SOUTH VALLEY WATER RECLAMATION FACILITY
PROJECT 4D
WEST JORDAN, UTAH

MECHANICAL
BIOREACTOR NO. 4 AIR
DIFFUSER SYSTEM PLAN

SOUTH VALLEY WATER RECLAMATION FACILITY		
WEST JORDAN UTAH		
THIS DRAWING IS THE PROPERTY OF SANITAIRE AND IS SUBMITTED IN CONFIDENCE. IT IS NOT TO BE REPRODUCED, COPIED OR DUPLICATED WITHOUT PERMISSION OF SANITAIRE.		
BIOREACTOR 1-4 STRUCTURAL, DROPLEGS & MANIFOLDS KEY PLAN		
ITT Corporation		
SANITAIRE® BROWN DEER, WISCONSIN 53223 ABJ®		
DRAWN BY: MRL	DATE: 12-4-07	DESIGN: NEW/REV
CHKD BY: MTR	DATE: 12-12-07	STD.
APPROV BY: DE	DATE: 12-13-07	SHEET: 2 OF 40
JOB: 07-67425		
S-2

BIOREACTOR 1-4
AERATION GRIDS
KEY PLAN

OX-9
GRID TYPE 15
PLAN VIEW 50
(2) BIOREACTORS 1 & 4 - REQ'D AS SHOWN
(2) BIOREACTORS 2 & 3 - REQ'D MIRROR IMAGE

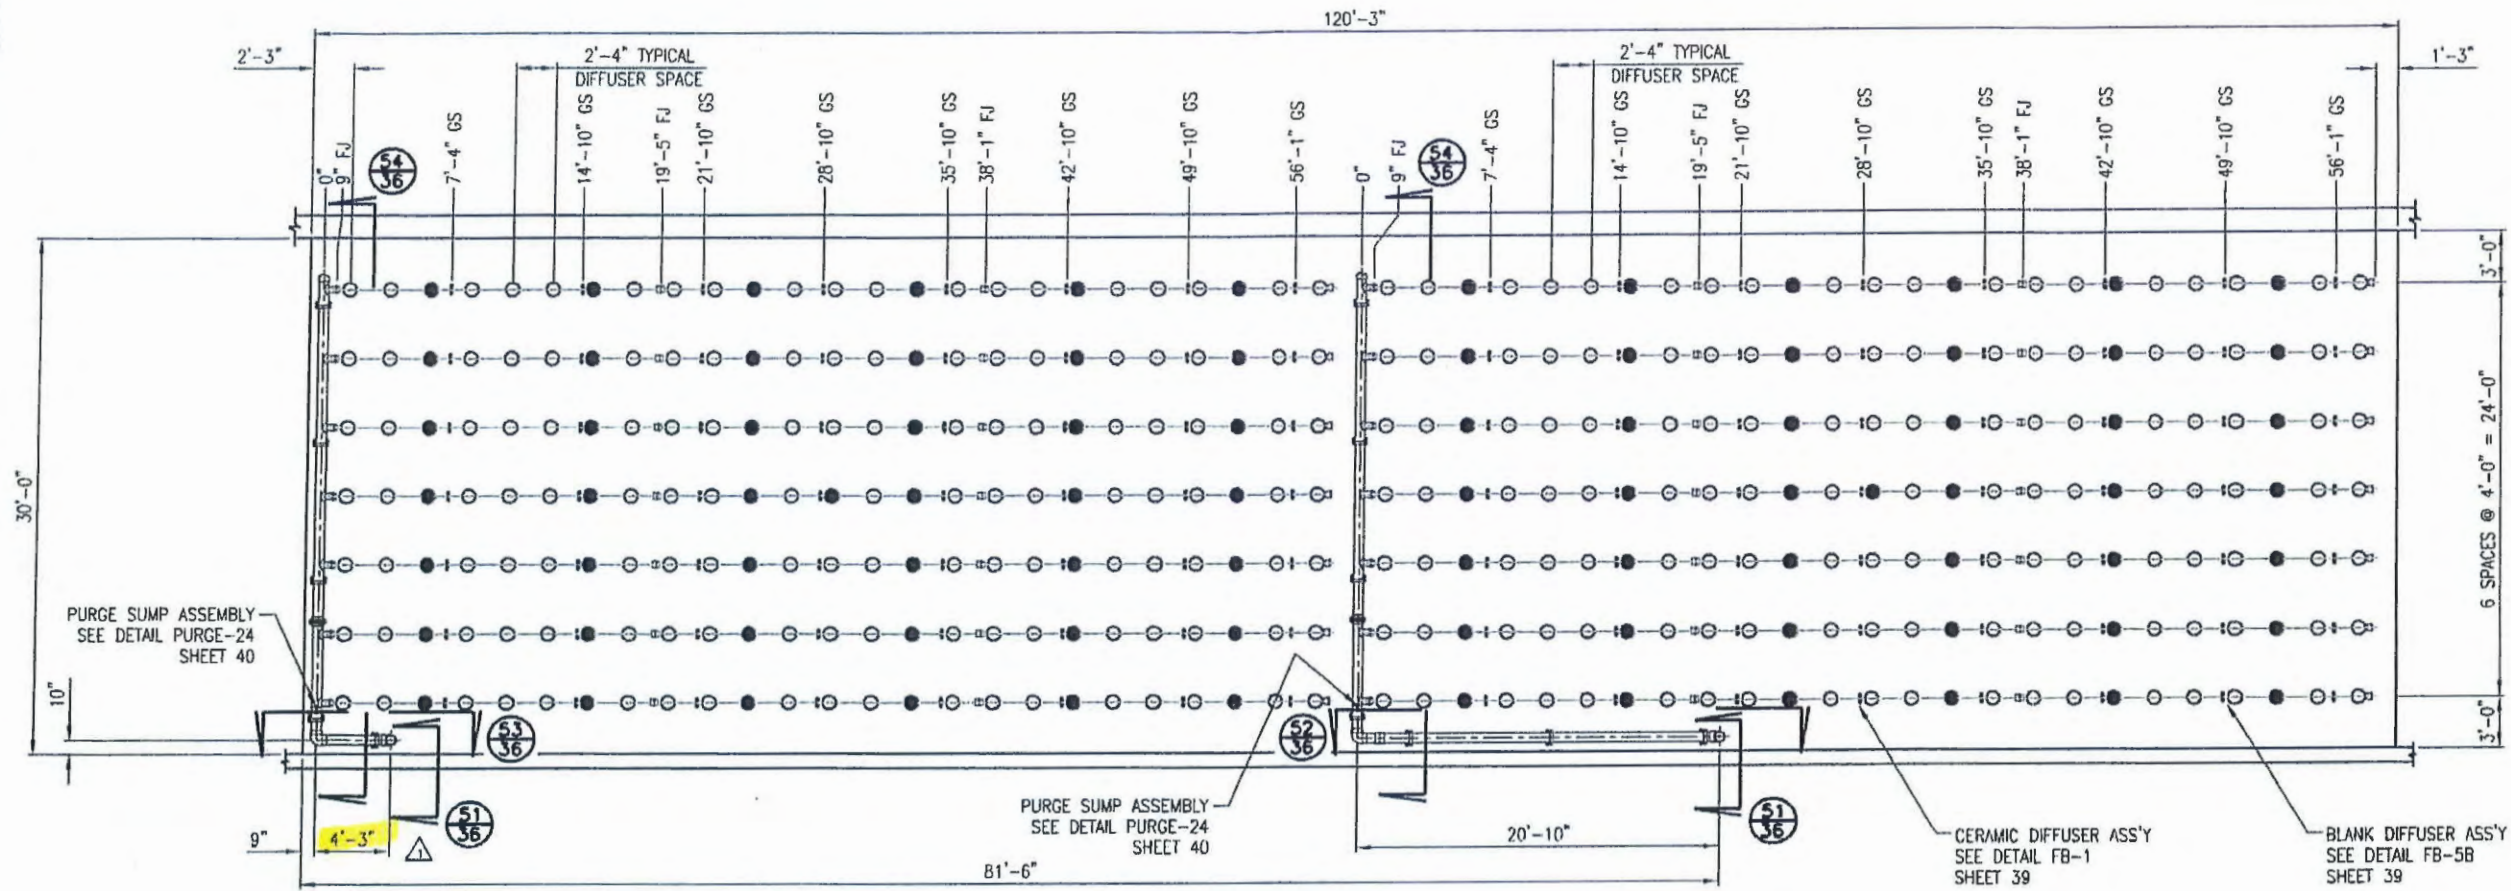
FOR THIS GRID:
REMOVE AND REPLACE ALL CERAMIC DIFFUSERS WITH EPDM MEMBRANE
DIFFUSERS AND PVC SUBPLATES. TYPICAL BOTH BIOREACTORS.
